Report Of The PCZBA Meeting 10/6/2015

Single Family & Duplex PUD @ Checker & Old Hicks, Fidelity Wes

STAFF REPORT

Item: PCZBA PETITION 15-04

PRELIMINARY SITE PLAN

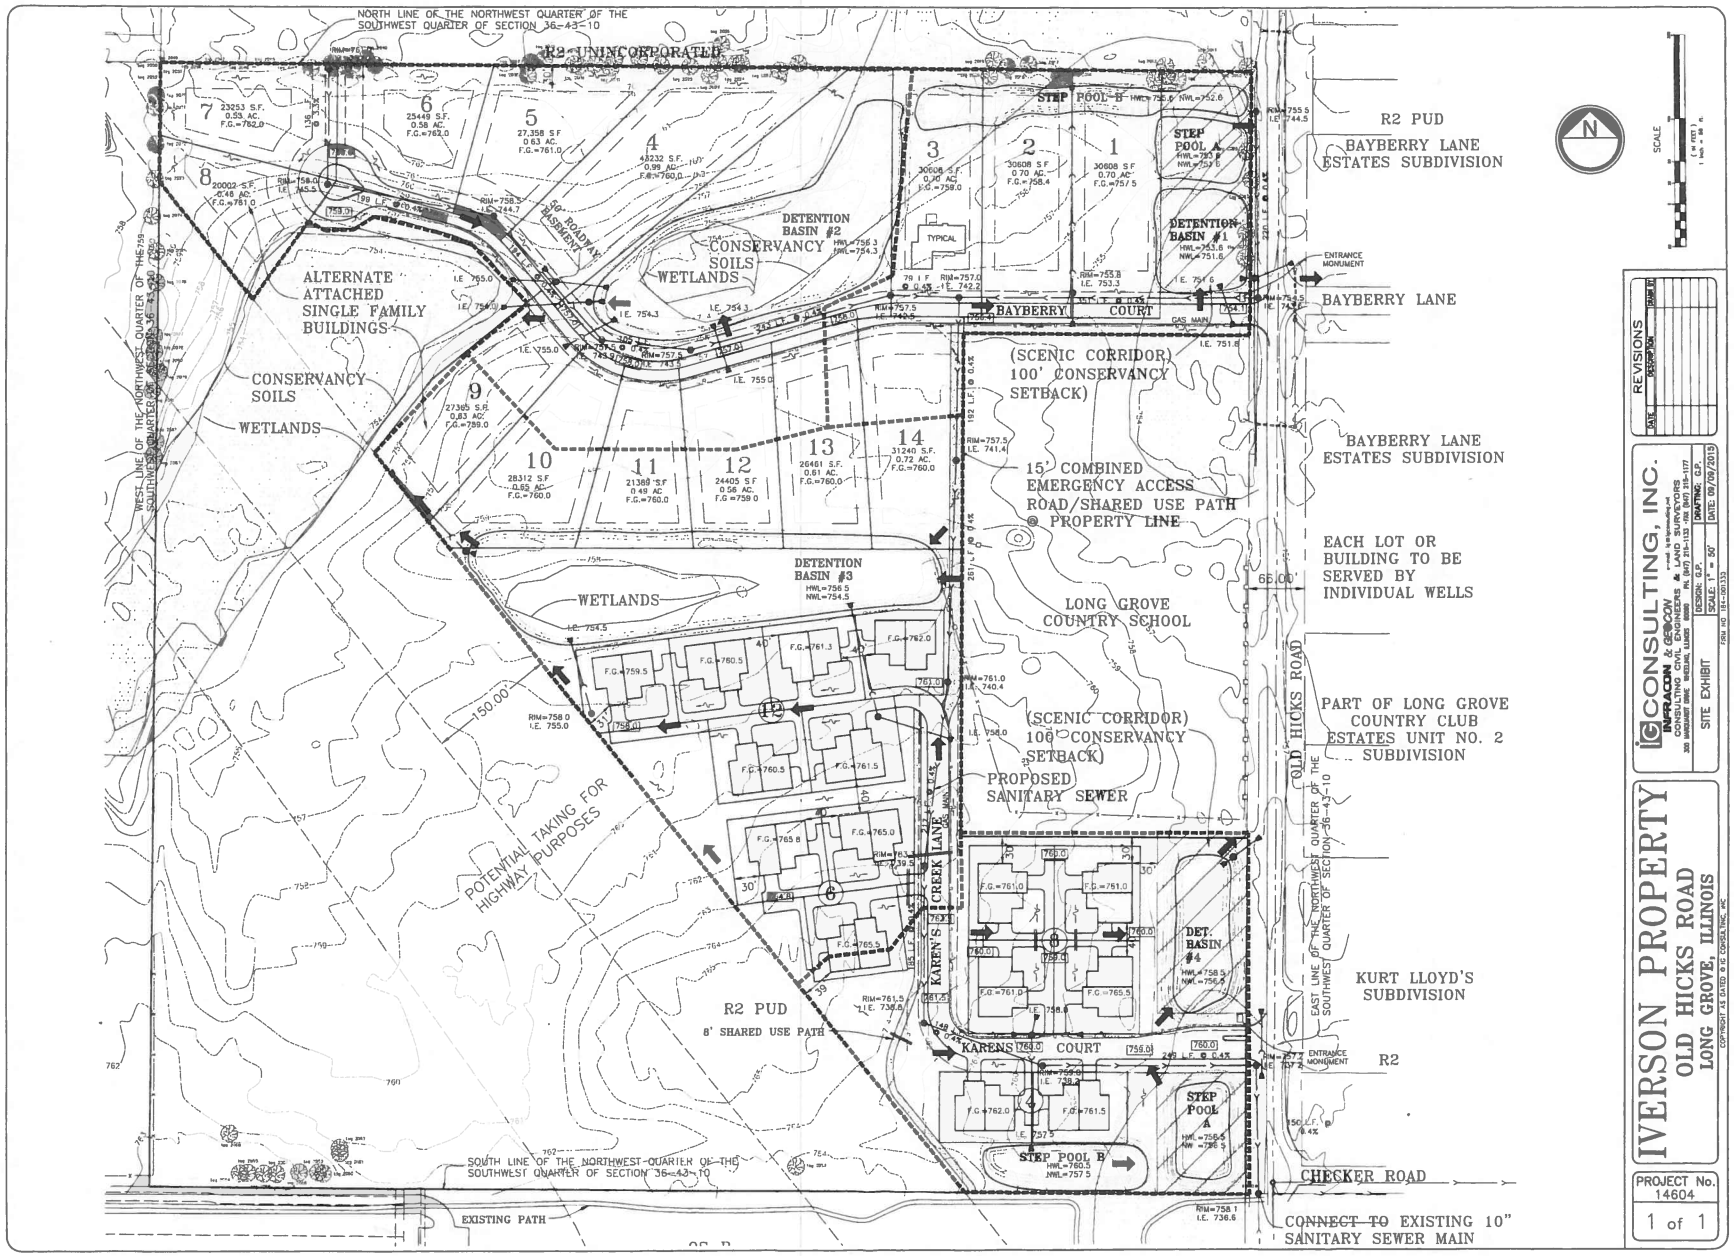
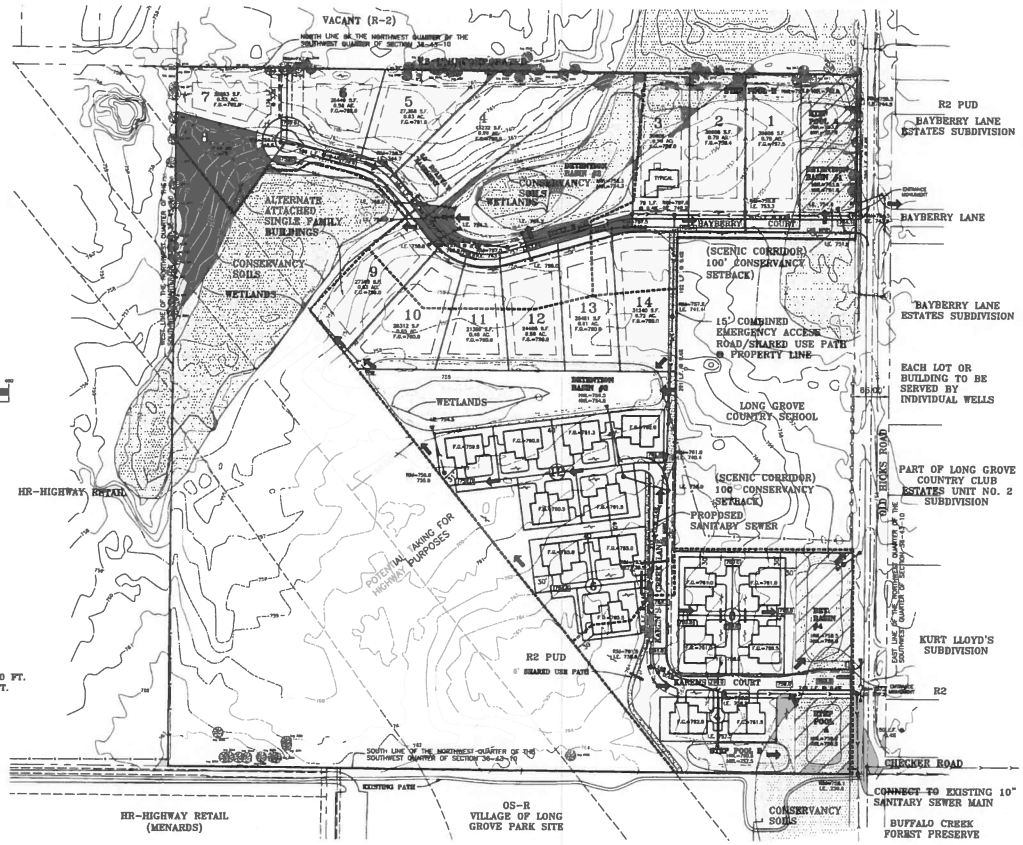
3) Stormwater – Stormwater detention will be accommodated via detention ponds located on "Outlots A thru D as identified on the preliminary plat. Stormwater will be conveyed to the detention areas via 12" PVC storm sewer. Detention areas in "Outlots A & D" are proposed to be included within the scenic corridor. Scenic Corridors are intended to provide a buffer between residences and traffic noise associated with collector streets, retain community character and provides habitat for plant and animal life. Existing woodlands and hedgerow within corridors are not to be destroyed. Detention areas are not anticipated in corridors per the subdivision code as follows;

The site plan includes a tree inventory for the property. Two species, the black walnut and black cherry are both protected species per the village code. The petitioner must comply with the provisions of the Village Tree Protection Ordinance with regard to this proposal.

The PUD Plat in combination with the proposed site plan is in conformance with the Village regulations with the exception of a soils map depicting soil conditions on the entire site. Conservancy soils have been identified on the property however.

1. We acknowledge the comment that the proposed storm water detention is located within the proposed Scenic Corridor of Old Hicks Road, we believe this is an appropriate use of the scenic corridor and should be discussed by the Village Plan Commission and Zoning Board of Appeals (PCZBA).

2. The field located wetland delineations are shown and labeled on the Preliminary Site Plan. The Wetland Report and the subsequent Jurisdictional Determination from the Army Corps is provided.

1. The Preliminary Site Plan has been provided at the largest standard scale (i.e. 10, 20, 30, 40, 50, 60, 100, 200) that shows the entire site on one, 24" x 36" sheet. Any larger would require splitting the view of the site onto two or more sheets and would make reading the plan confusing. The plan is very legible at its current scale, which is 1" = 100' and is not uncommon for Preliminary Engineering design. As a convenience to the PCZBA we have also included a 1"=50' SITE EXHIBIT on larger format paper.
